Lead Local Flood Authority

TOWN AND COUNTRY PLANNING ACT 1990 LEAD LOCAL FLOOD AUTHORITY RECOMMENDATION

LOCATION: Land North Of Carisbrook Road Mitcheldean Gloucestershire

PROPOSED: Outline application for the erection of up to 180 residential dwellings (including affordable housing) with public open space, landscaping and vehicular access points (all matters reserved except for means of access)

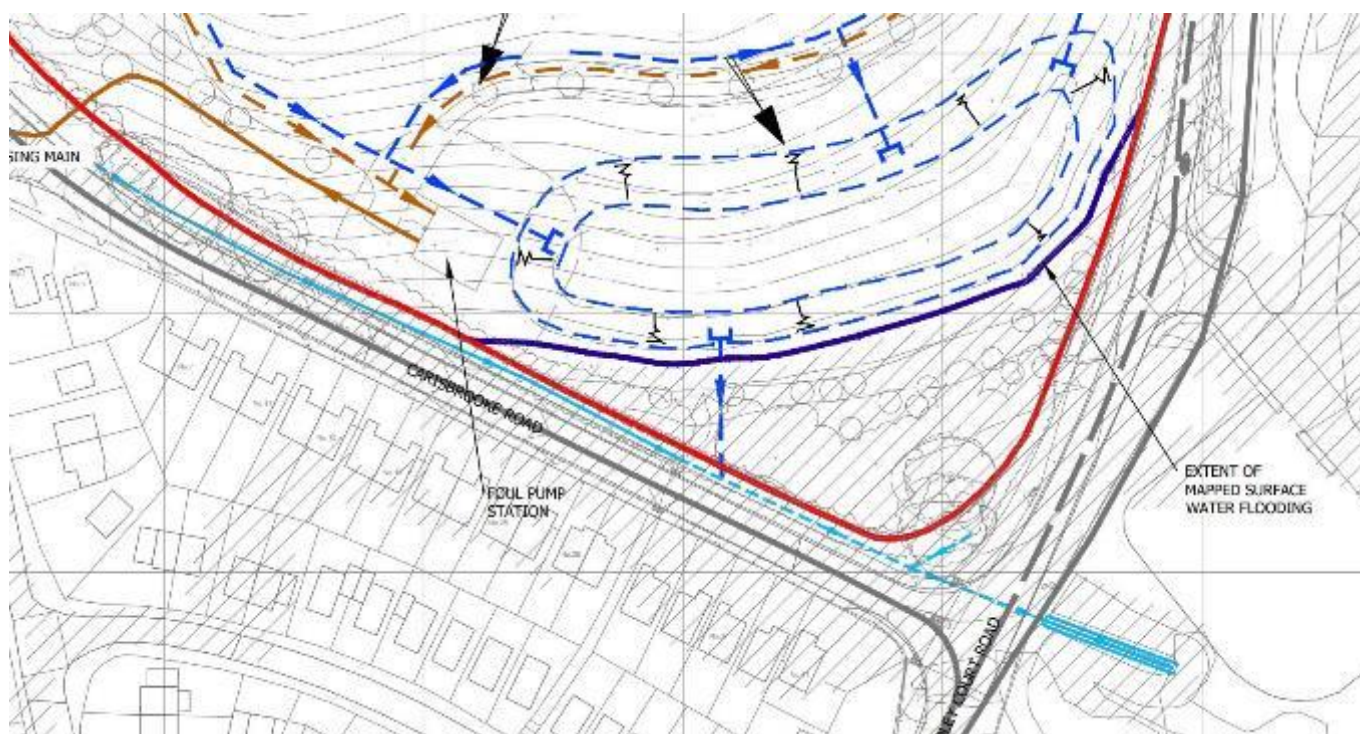
The Outline Drainage Strategy (6326/01-04-B) in Appendix 7B shows that the existing watercourse the development will discharge to is outside of the redline boundary (see extract below). Riparian responsibility for the maintenance of watercourses lies with the landowner and not including this within the site provides the opportunity for the watercourse to be missed off any future changes to land ownership or from any maintenance strategies associated with the development. It's the LLFAs view that this and any other watercourses (both open and culverted) on the site are included within the redline boundary so they can be included in future maintenance regimes if the development is granted.

The LLFA has no objections to the surface water drainage strategy subject to the following conditions, however, recommends the redline boundary is reviewed and, where necessary, the watercourses on the boundary of the site included within it.
